SITE PLAN
HOMESTEAD, PHASE 1
LOT 9, BLOCK F
~AMENITY CENTER~

SP2023-046: Site Plan for Amenity Center within Homestead

PROJECT NUMBER: SP2023-046
PROJECT NAME: Site Plan for Phase 1, Homestead Subdivision
SITE ADDRESS/LOCATIONS: 3200 FISHER RD, ROCKWALL, 75032

Sheet
E1.00

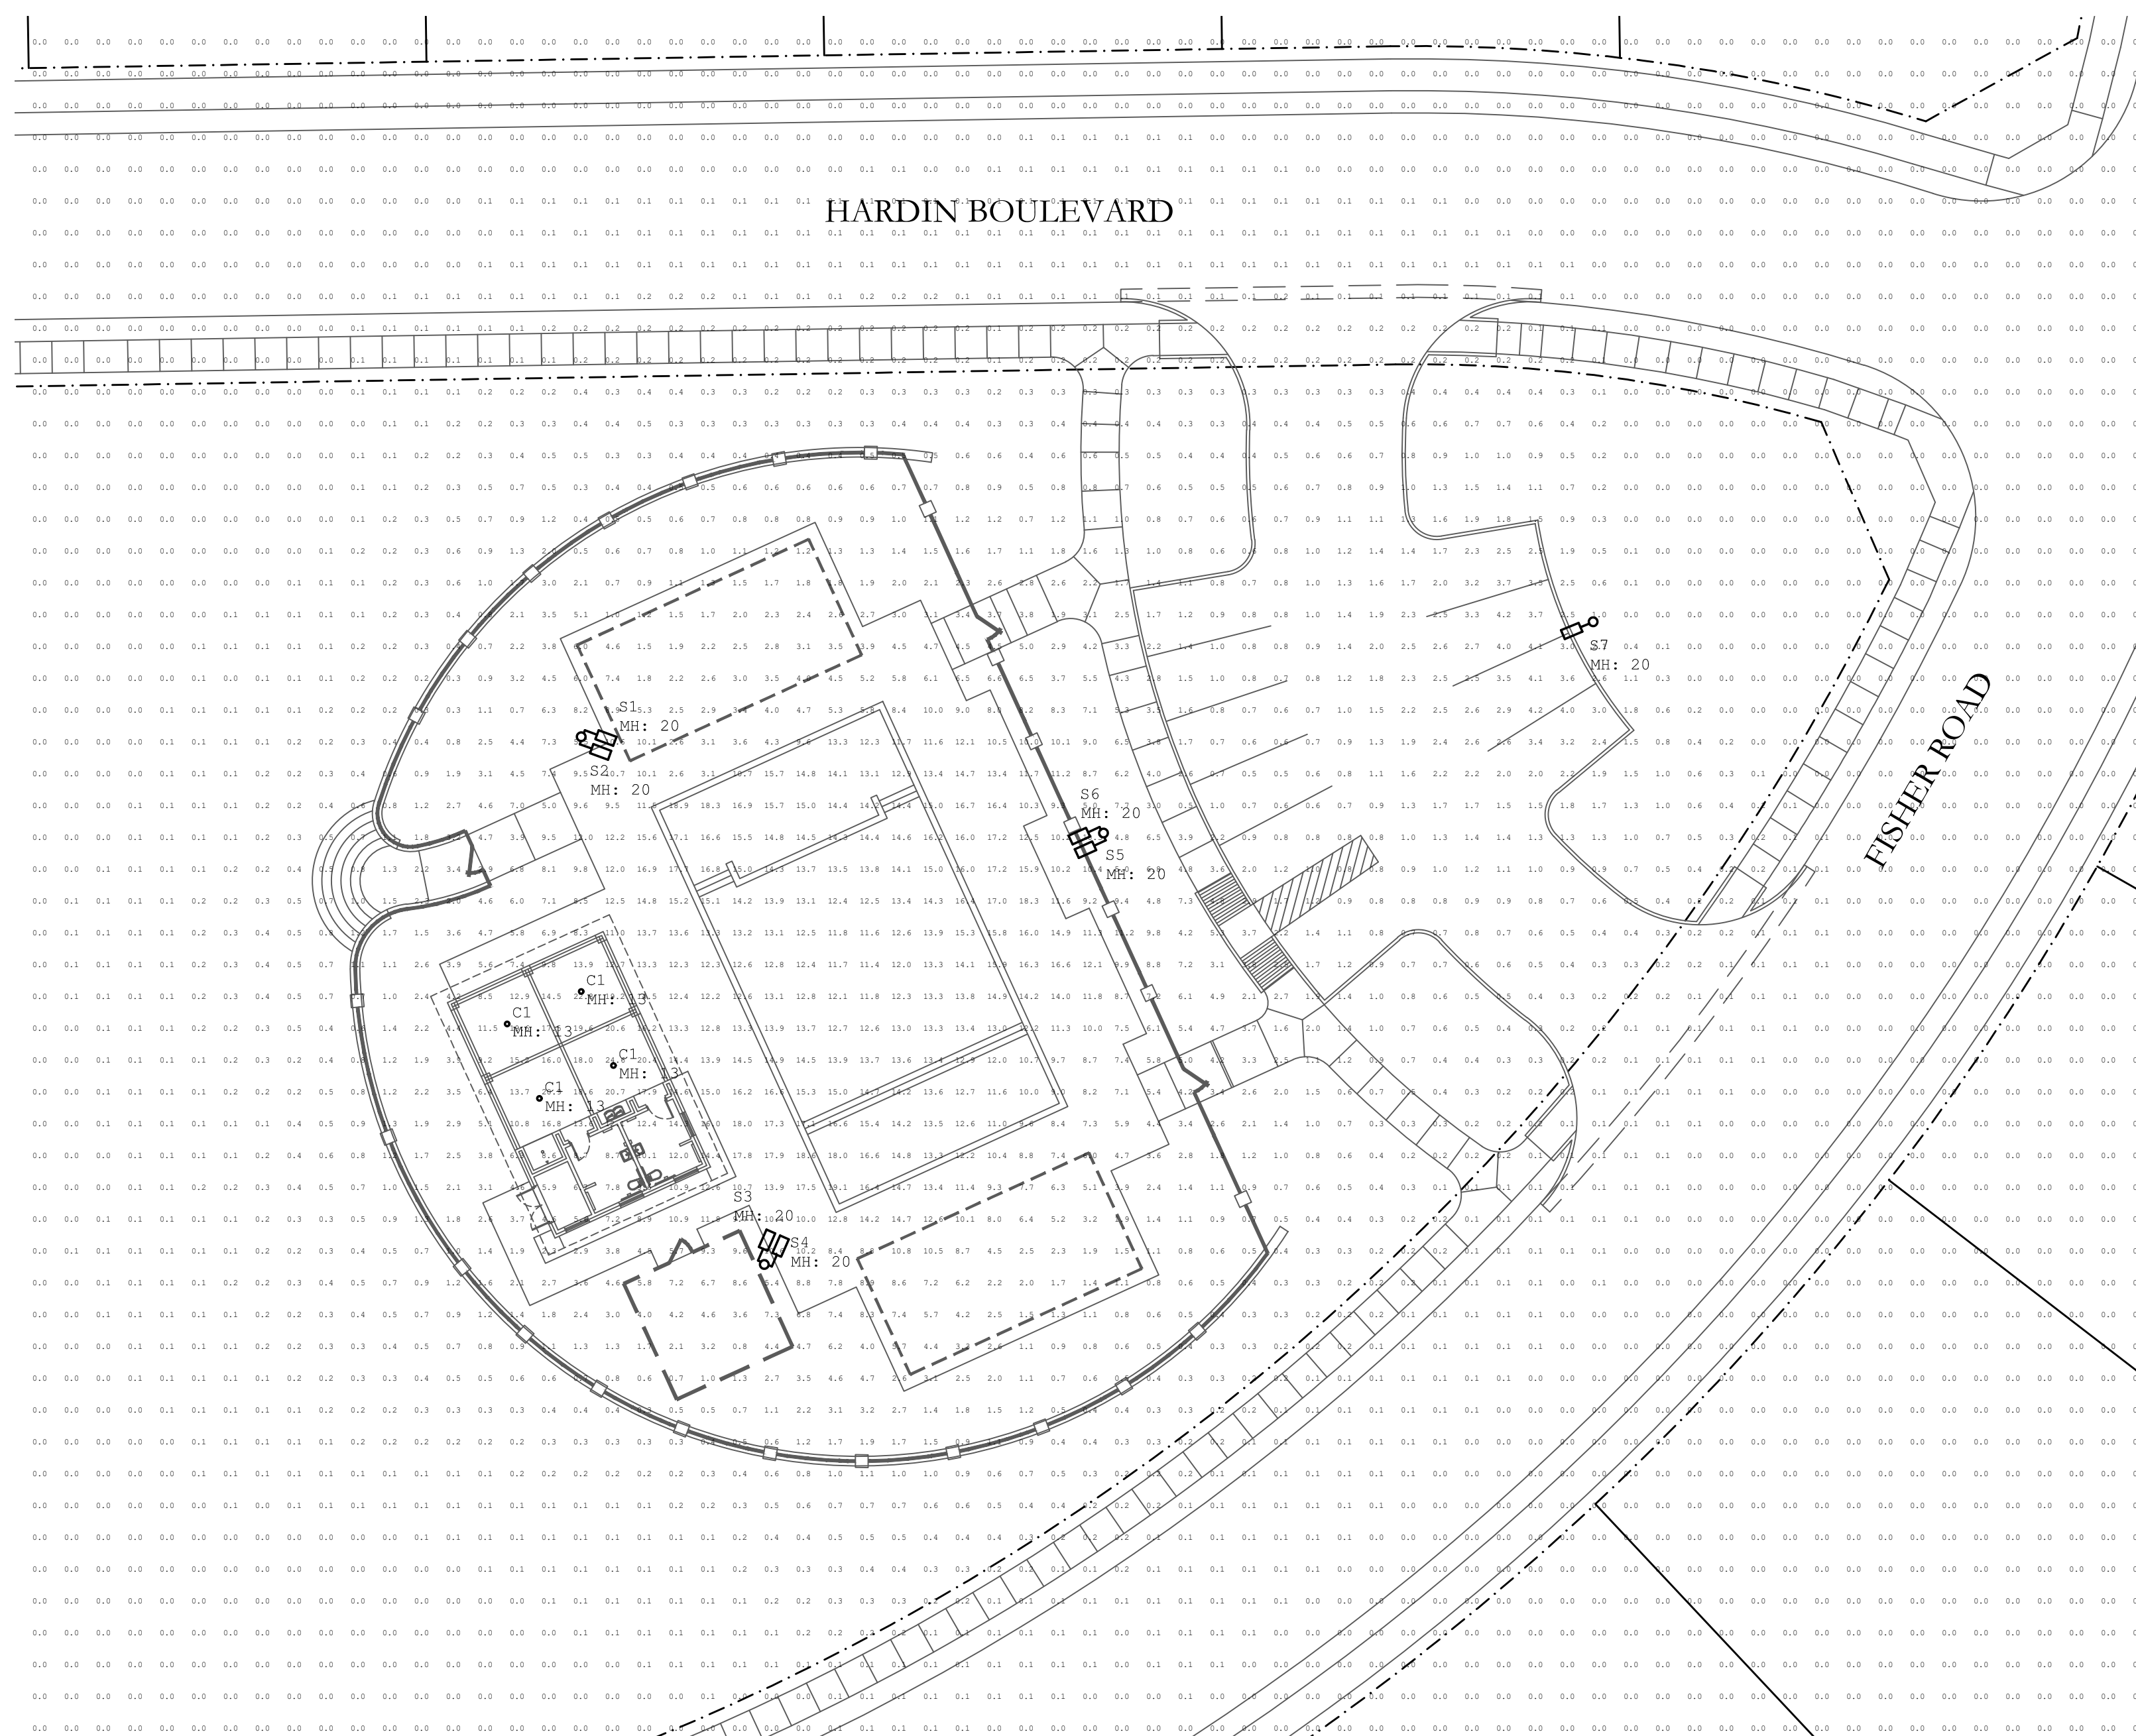
M.6 Photometric Plan:

- (1) The foot-candles cannot exceed 0.2 FC at the property lines. (Subsection 03.03. G, of Article 07)
- (2) No light pole, base or combination thereof shall exceed 20 feet. (Planned Development District 92)
- (3) Up lighting is not permitted for any of the proposed light fixtures. (Subsection 03.03, of Article 07)
- (4) Please provide cut sheets for all proposed lighting fixtures. (Subsection 03.03, of Article 07)
